TECHNICAL BULLETIN		Mfg: GM
	October 2010	Model: CATERA
	TB 2544	Liter: 3.0L
		V I N: R
		Year: 97-08

Engine Noise on
2005 GM 3.0L VIN R Engines

Bulletin Diagram: FIGURE 1. DAMAGED GEAR AREA - VALVE TRAIN

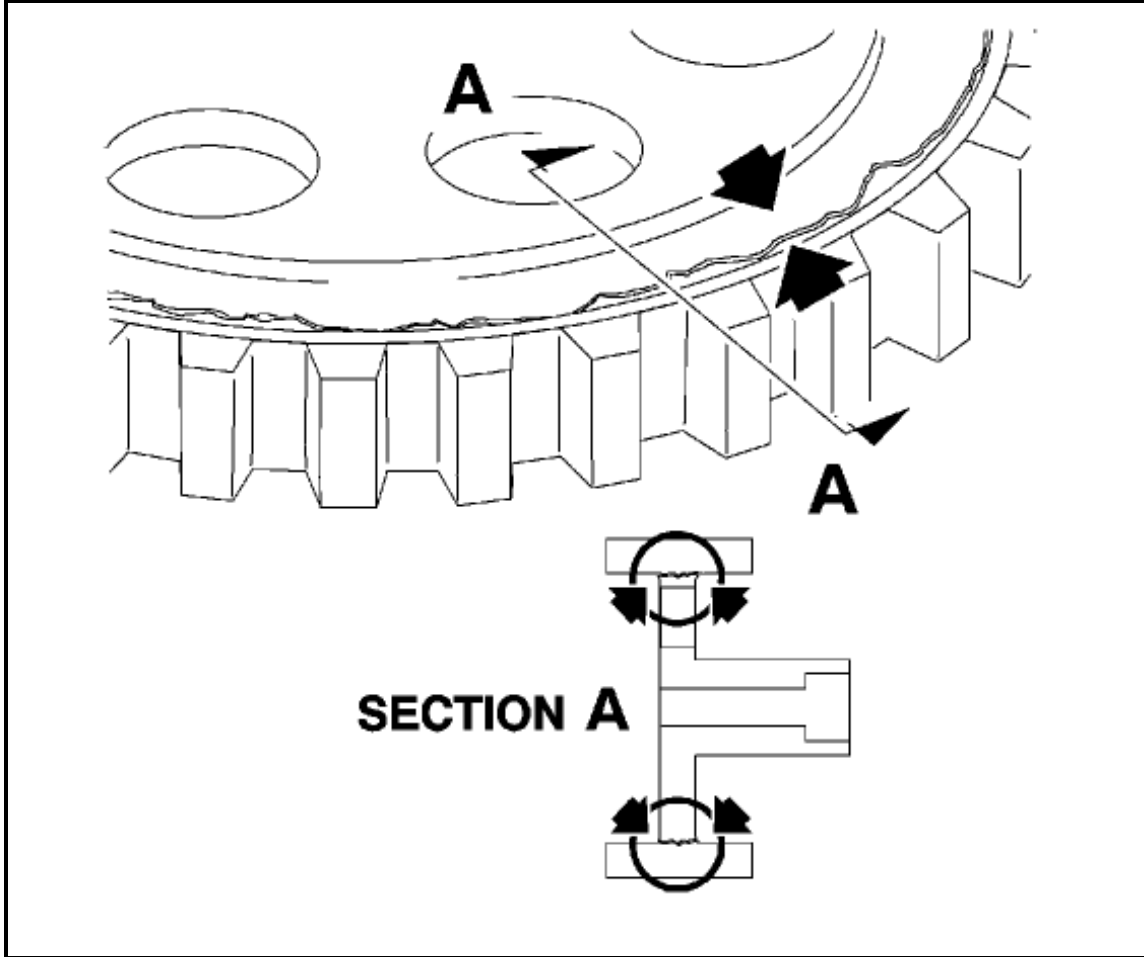
The cause of this condition may be caused by either of the bank 2 (front bank) timing belt camshaft sprockets being cracked near the base of the tooth area of the camshaft sprocket. Refer to the Figure 1 which shows a typical location of fatigue crack. Engines affected with this condition were built between and including VIN breakpoints 5Y501038 to 5Y505543.

To correct this condition, it is suggested to replace both bank 2 (front bank) timing belt camshaft sprockets and bolts. The gears are available with Part #90573286 and the bolt is available with Part #90573287. When replacing the timing gears it may be necessary to renumber the gears in accordance to the gears shown in Figure 2 to assist in future timing of the gears.
